# Access Compliance Report

## Public Rights-of-Way

Intersection ID: 15340	Main Street: CHARLOTTE_DR	Cross Street: LATTIMORE_ST	Location:	E
ADA ID: AC2CF553D7AF	Ramp Type: Perp	Initial Pass/Fail: Fail	Overall Compliance: No	Severity Score: 12.5
Codes/Mitigation Info/Possible Solution		Field Measurements/Component Compliance

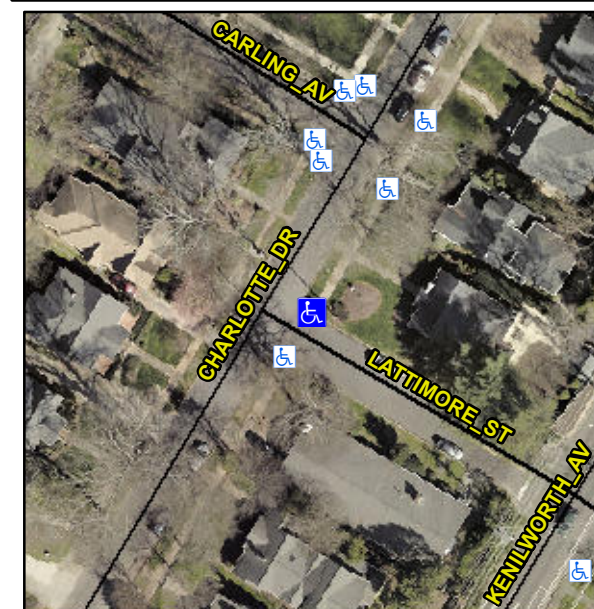
**Not Found, R304.2.2**

Compliance	Description	Data	Compliance	Description	Data
N/A	Ramp Length (in)	132.0	No	Ramp Slope (%)	11.8
Yes	Ramp Width (in)	48.0	Yes	Ramp XSlope (%)	1.1
N/A	Flare Type LT	N/A	N/A	Flare Type RT	N/A
N/A	Flare Slope LT (%)	N/A	N/A	Flare Slope RT (%)	N/A
N/A	Flare Traversable LT?	N/A	N/A	Flare Traversable RT?	N/A
N/A	Landing Length (in)	N/A	N/A	DWS Provided?	N/A
N/A	Landing Width (in)	N/A	N/A	DWS Contrast?	N/A
N/A	Landing Slope (%)	N/A	N/A	DWS Length (in)	N/A
N/A	Landing X Slope (%)	N/A	N/A	DWS Full Width?	N/A
N/A	Landing Curb? (Y/N)	N/A	N/A	DWS Offset (in)	N/A
N/A	Shared Landing?	N/A			
N/A	Gutter Ponding?	N/A	N/A	Gutter Slope (%)	N/A
N/A	Gutter Lip Ht (in)	1.0	N/A	Gutter X Slope (%)	N/A
N/A	Painted X Walk1?	No	N/A	Painted X Walk2?	N/A
	X Walk 1 Direction	To SW		X Walk 2 Direction	N/A
N/A	X Walk 1 Width (in)	N/A	N/A	X Walk 2 Width (in)	N/A
	X Walk 1 Slope (%)	1.1		X Walk 2 Slope (%)	N/A
	X Walk 1 X Slope (%)	4.2		X Walk 2 X Slope (%)	N/A

**Remove & Replace Entire Ramp.**
